MATILIJA DAM

F.E. BONNER 5/25/49

MEMORANDUM RE
MATILIJA DAM - VENTURA COUNTY

F. E. Bonner
Consulting Engineer
San Francisco, California

PLATE 1

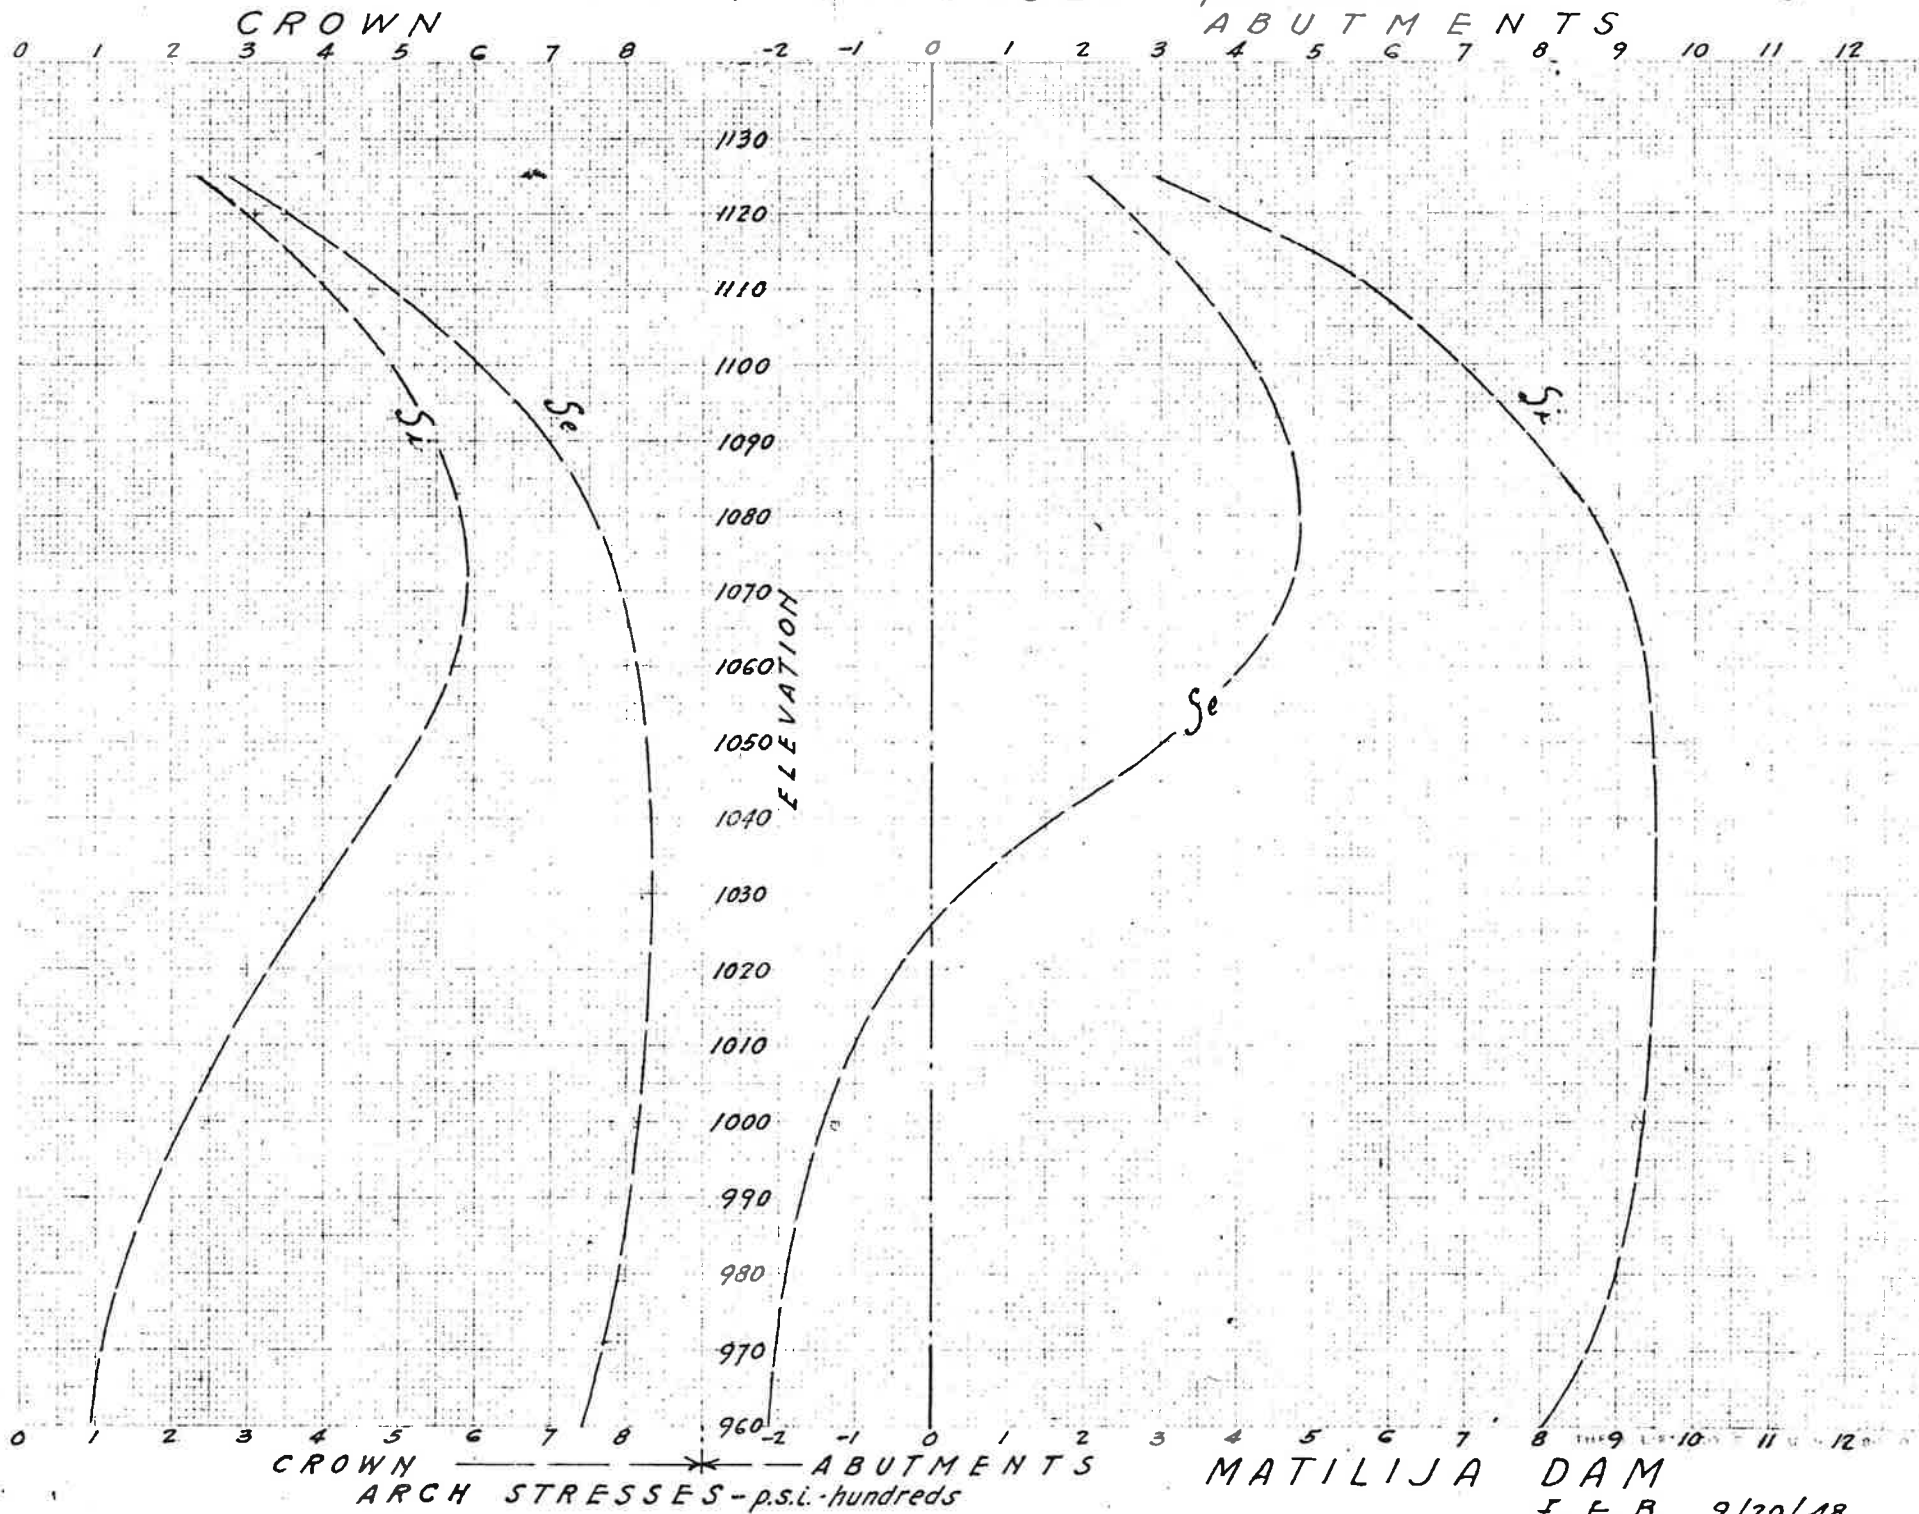
With the improvement of the technique of making high strength concrete in recent years, the tendency has been toward the allowance of greater stress limits in the design of arch dams. In the design of the Matilija arch full advantage was taken of this tendency and the resulting structure has more slender proportions than usual. A general check of the arch stresses shows rather high values over large sectors but they can hardly be rated as dangerously high for good quality concrete. Plate 1 herewith shows the stresses to be expected under full water load. It will be observed that the crown stresses at the extrados range slightly above 800 p.s.i. up to elevation 1070 and more than 900 p.s.i. may develop at the intrados of the abutments. In current conservative practice a maximum working stress of 800 p.s.i. is customary. On the other hand, the record of the Smith Emery Laboratory tests of the concrete placed in the arch indicates average 28 day compressive strength of approximately 4500 p.s.i. This is better quality than usual and serves to compensate for the high unit working stress of the design. The factor of safety of 4 to 5 which is provided is about the margin considered necessary to allow for indeterminate internal stresses arising from other forces than the water load. One feature not to be overlooked is the added load which may be placed on the arch by the accumulation of silt in the reservoir. It is known that the tributary watershed rates high in silt production. No investigations have been made in this specific basin, but conditions are similar

To summarize my opinion regarding the adequacy of the arch it may be stated that while conservative practice would require a structure of more ample proportions, particularly in view of the precarious foundation and the proposal to pass large flood flows by free overfall, the excellent character of the concrete construction compensates for the slimness of the cross section in such degree that the arch is safe against com-

MATILYA DAM
PROFILE ALONG AXIS

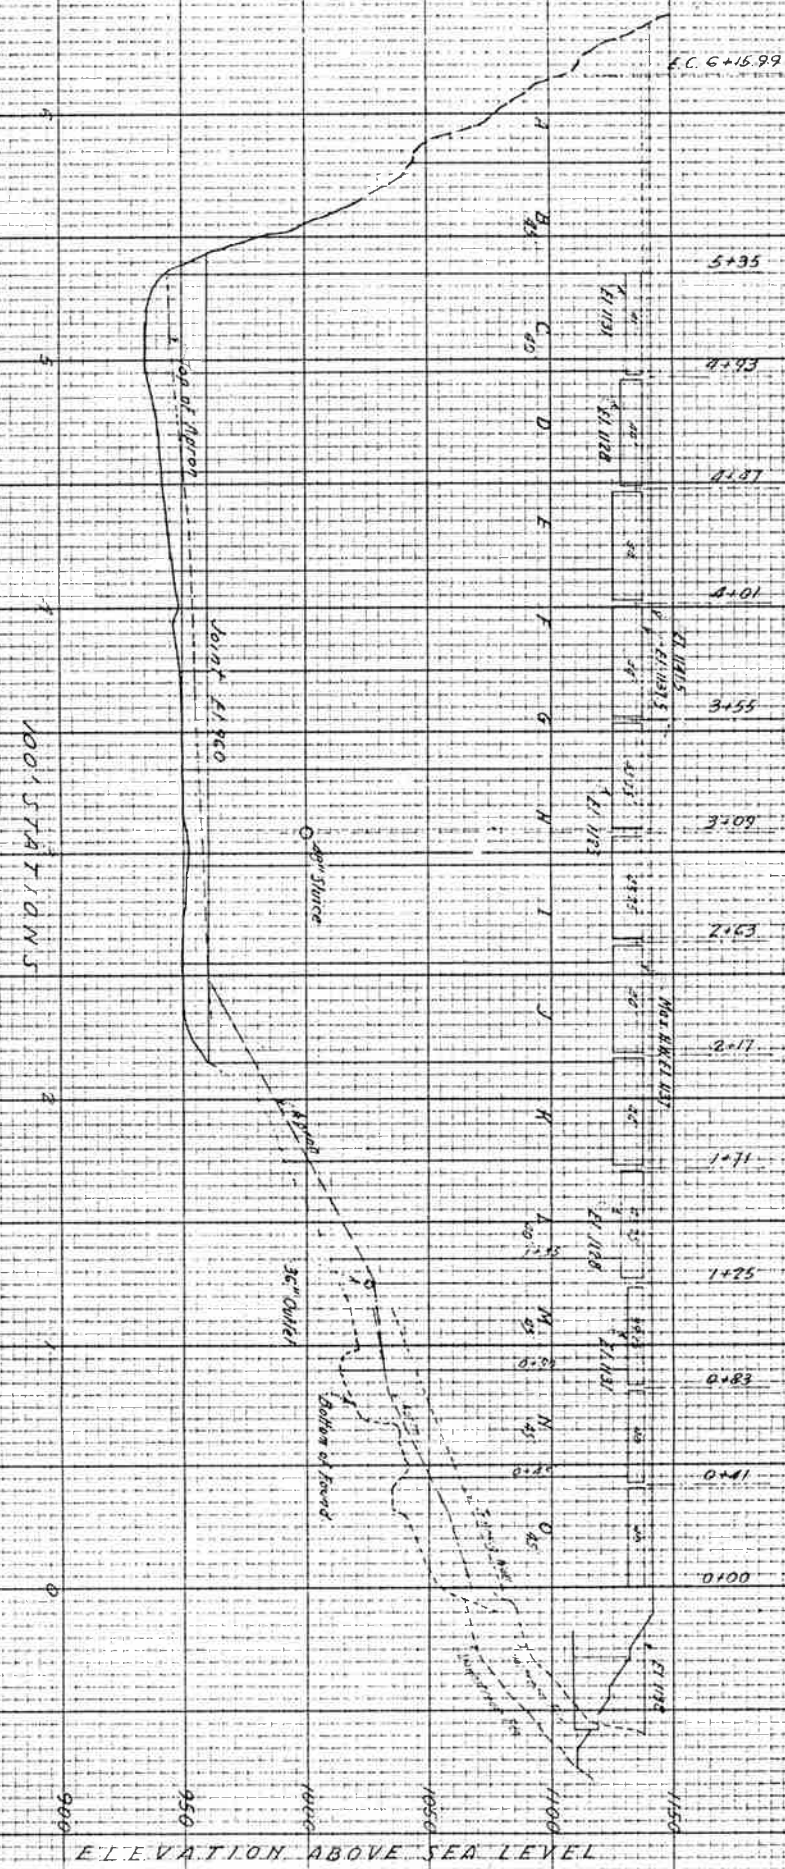
The dimensions and elevations of the spillway bays on the crest of the dam are shown by Plate 5, which is a developed profile of the dam along the axis. A curve showing the

PRELIMINARY LAYOUT
 TUNNEL SPILLWAY
 MATILIJIA DAM
 SCALE 1"=100'
 F.E. BORNHAR 1/20/49

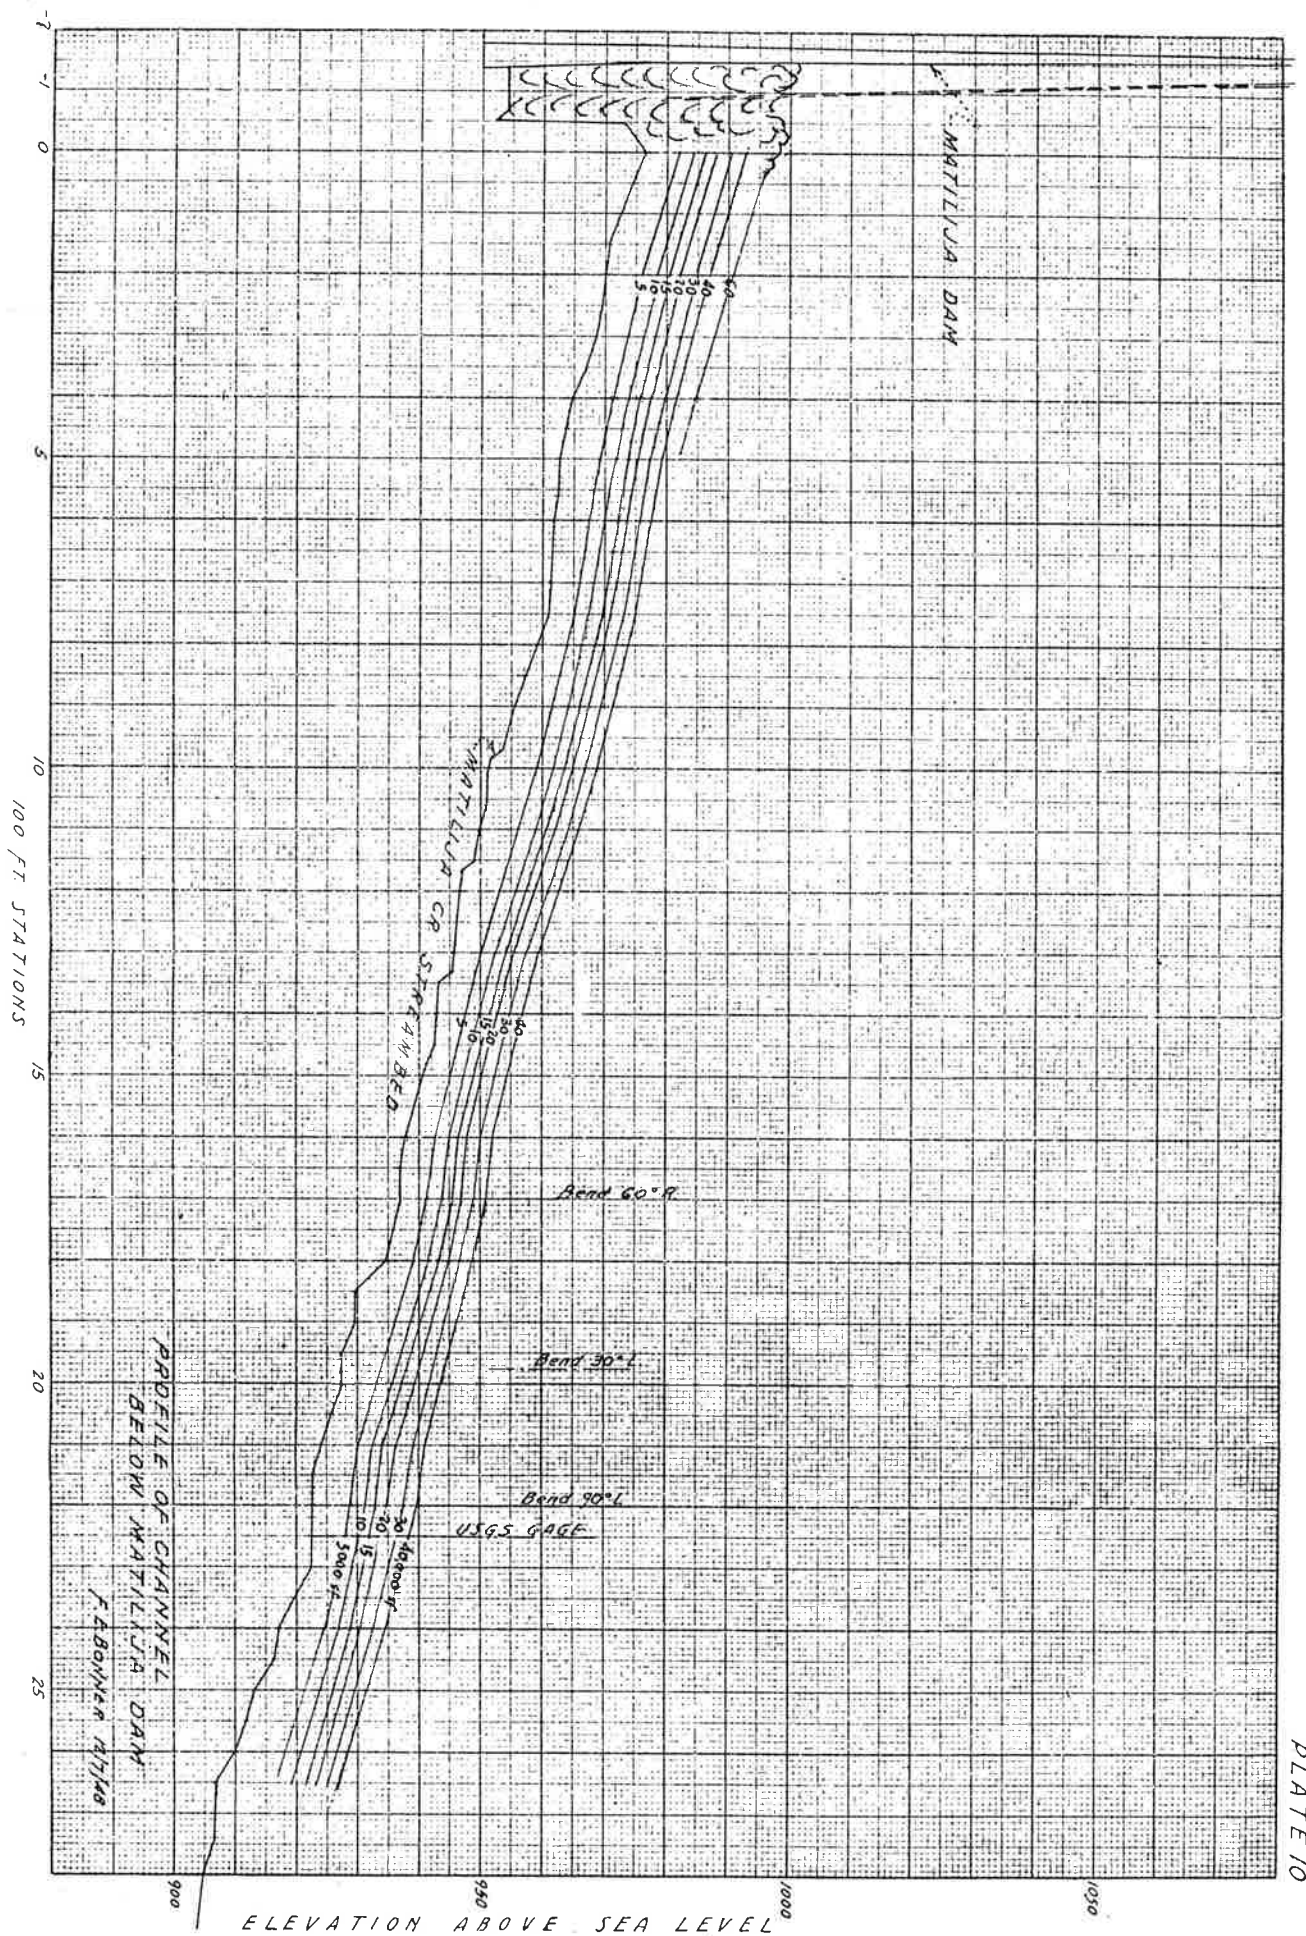
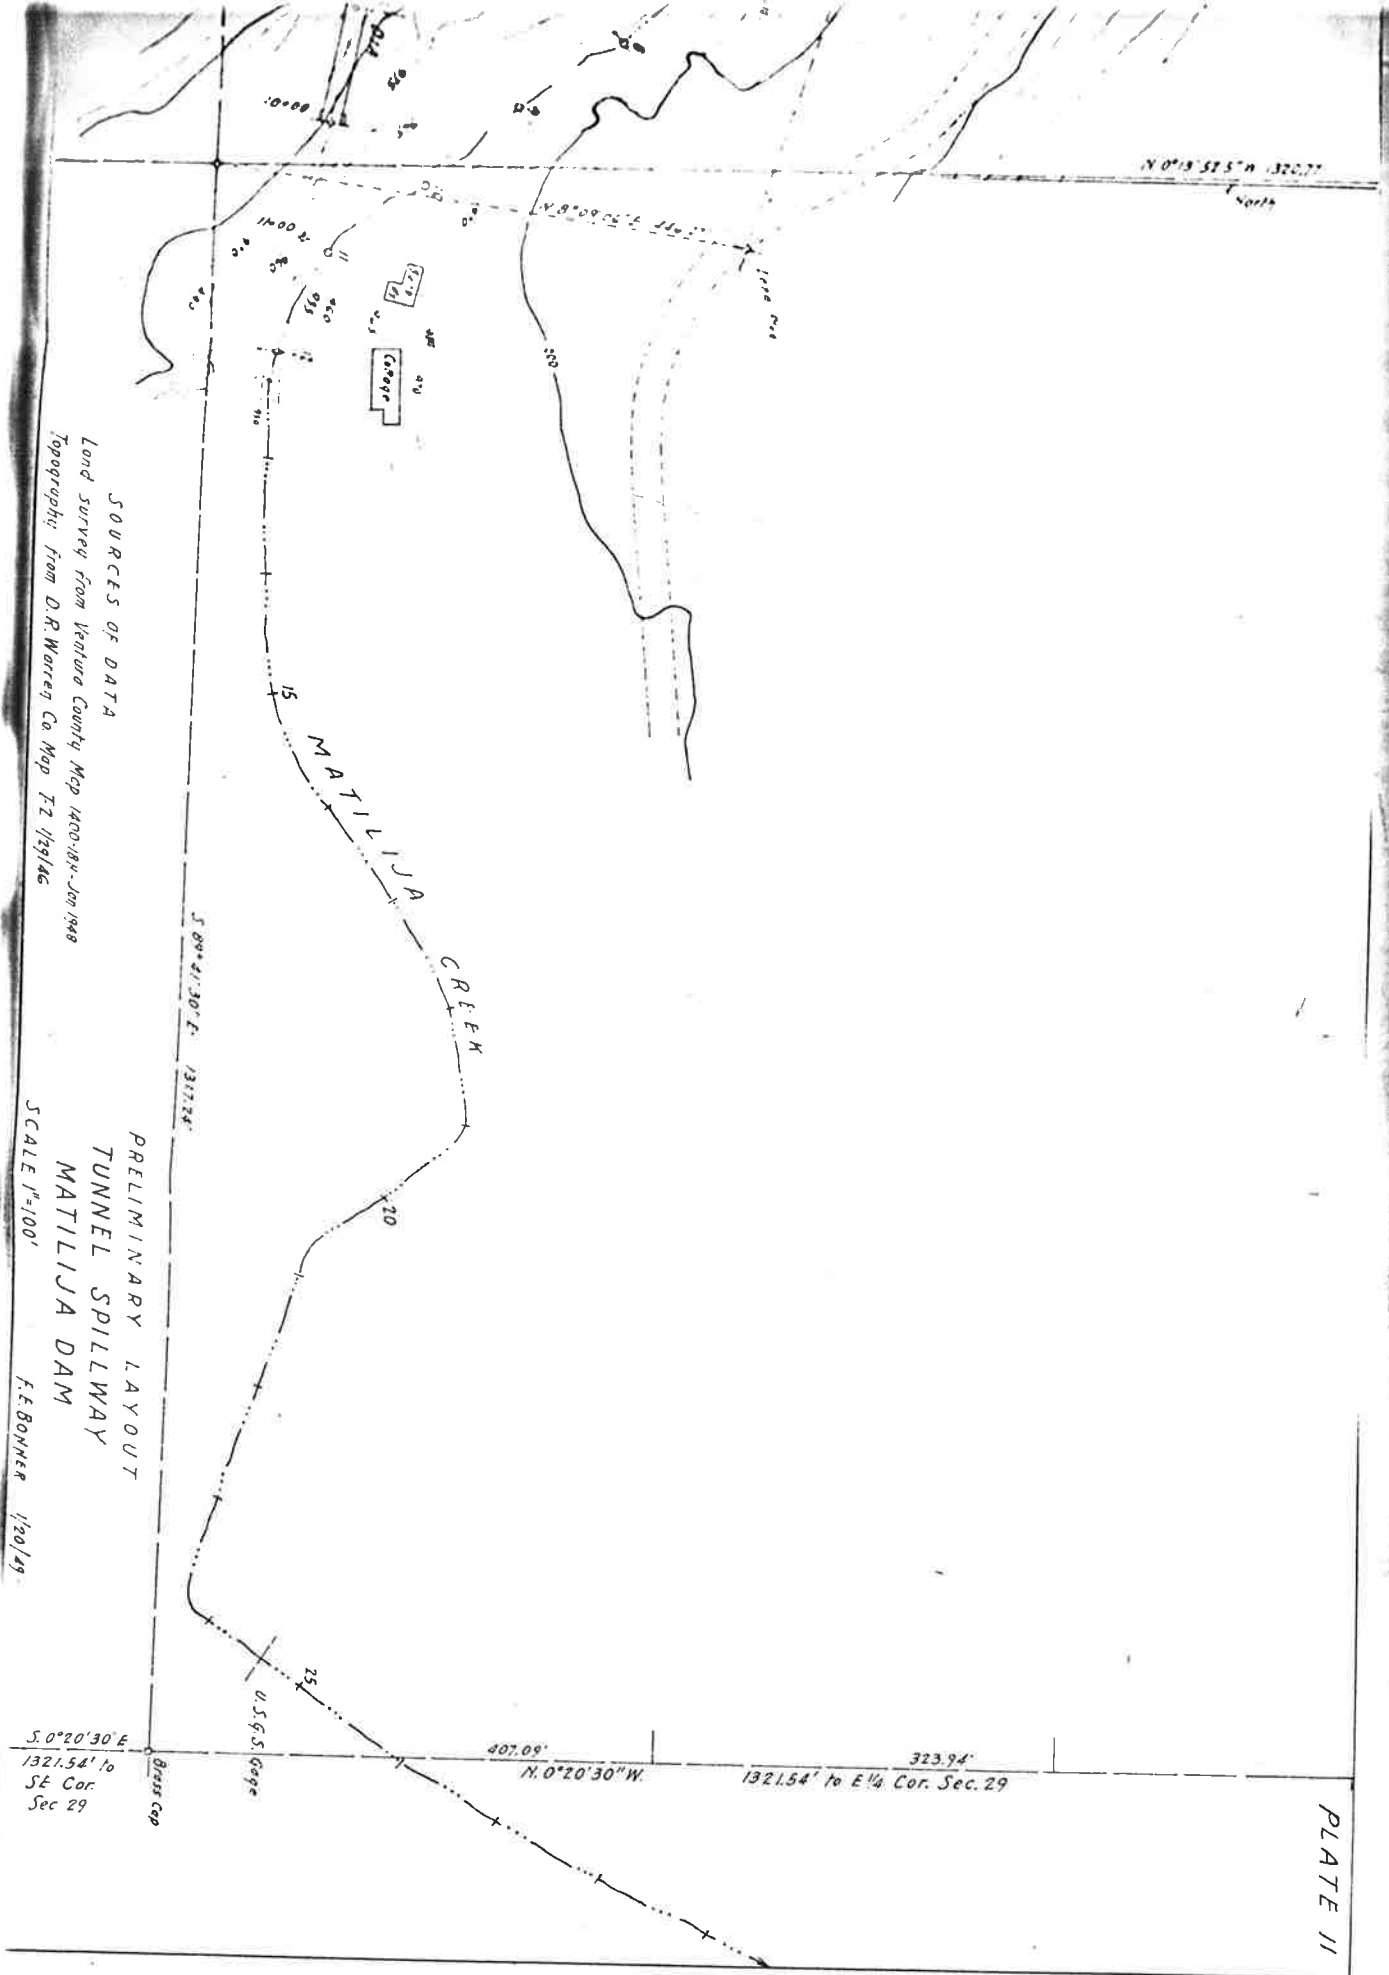
Further study demonstrated that the most favorable prospect for a separate spillway comprises a tunnel around the right abutment of the dam. A preliminary plan is presented by Plate 11 herewith. Plate 12 shows the design in profile. The concrete entrance weir, with crest at elevation 1115 would consist of three bays, each 45 ft. wide and discharging to steep inclined tunnels of 10 ft. diameter. At the bottom of the 45° slope the three tunnels would be merged by transition section into a single concrete lined tunnel of 16.5 ft. diameter extending 650 ft. on 7.5% grade to a junction with Matilija Creek just above the Springs. With reservoir water level at elevation 1125 this spillway would discharge about 16,000 sec. ft. In the opinion of the District's geologists the sandstone ledge formations, through which the tunnel would penetrate at right angles, is entirely suitable for this type of construction. The cost of construction is

estimated at \$670,000 without crest gate control. The effective capacity of the reservoir would be reduced 1200 acre feet. In the event crest gates were added to avoid this loss of storage capacity, the cost would be increased about \$60,000. Map data upon which the plan was based is subject to question and reliable surveys are needed before detailed layout, quantity calculations and cost estimates may be undertaken. This is particularly true at the site of the weir.

(b) Topographic survey and geological investigation be made of the area involved in the suggested tunnel spillway around the right abutment of the dam to serve as a basis for detailed plans and estimates.
